25240 - NAVAJO NATION PEACEMAKING BUILDING & AMPITHEATER

Addendum **ADD-1.0**

ADDENDUM 001

A5 OVERALL ELECTRICAL SITE PLAN

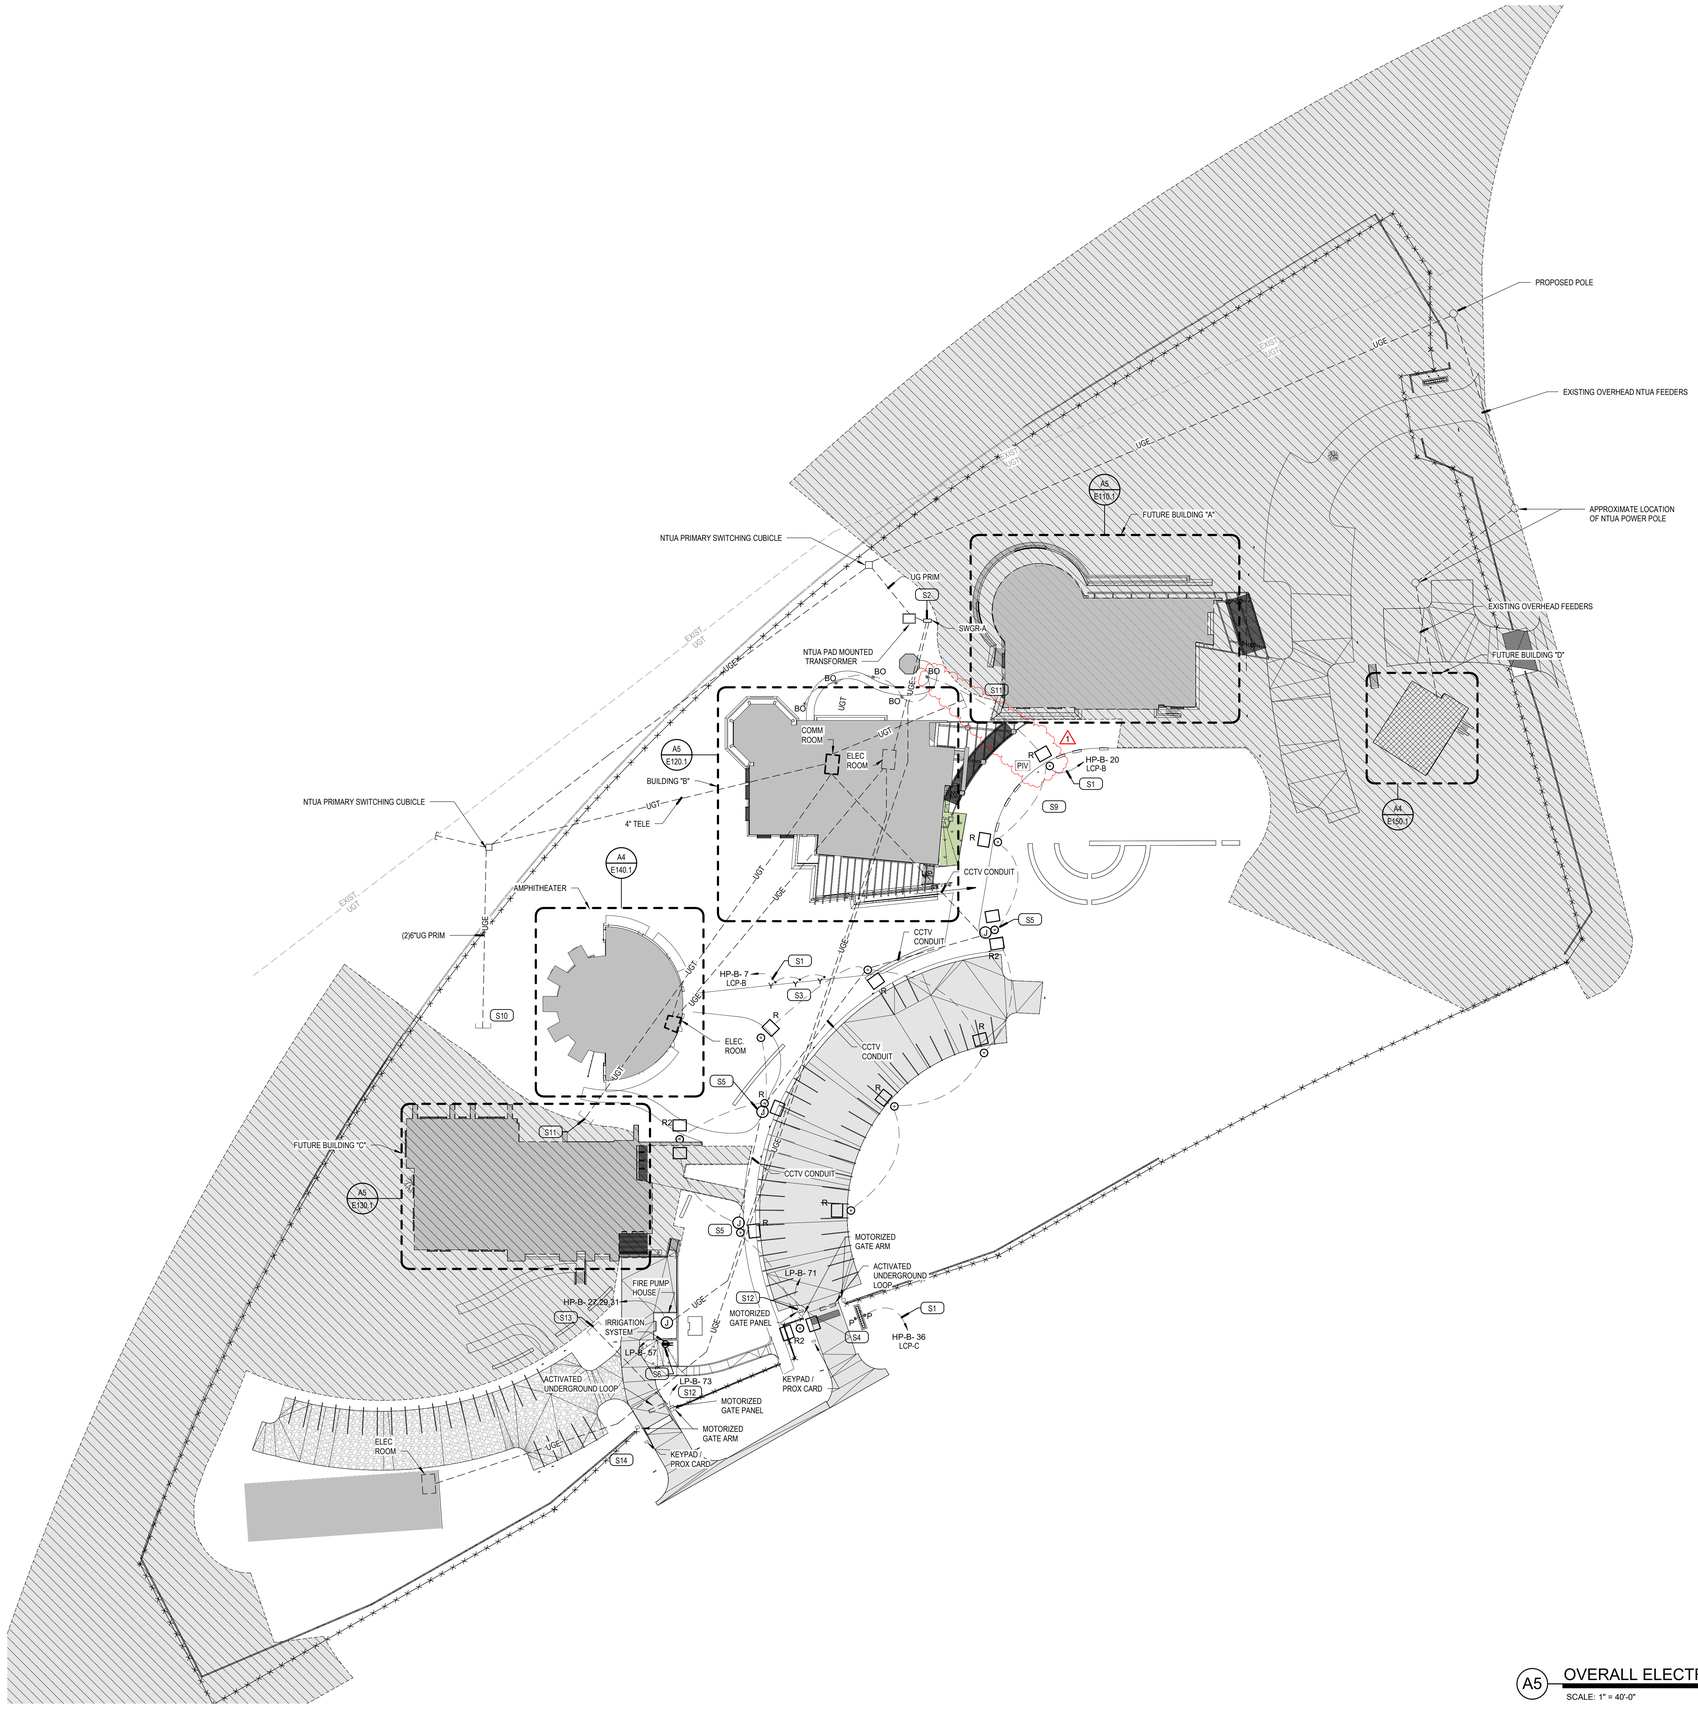
11	There are 5ea BO fixtures shown on ES100.1 that are not on the fixture schedule. Can you get me a specified part number for them.	The Lighting Fixture Schedule has been updated to include fixture BO and the approved Manufactures on Sheet E600.6 in Addendum 01. The Above All LED Moon is the Basis of our design.		
	12	Is Heat Soaking required for the tempered glass	Section 08 80 00 2.4 B 2 states that heat soaking is required		
	13	Specs show VNE1-53 but drawings show Solarban70, which is to be used	Solarban 70 (Vitro) on clear, as indicated on the Drawings, is the basis of design. Section 08 8000 will be revised by Addendum to list Solarban 70, with Viracon and other listed manufacturers acceptable if they meet its published VLT, SHGC and U-value.		
	14	Drawings callout Curtainwall at some elevations but no Curtainwall spec was provided and none of these windows require to be curtainwall. Is it storefront but with the glazing plane as the front	There is no "curtainwall". Everything is storefront with the glazing plane to the front for B3 and glazing to the center for the remainder of the windows
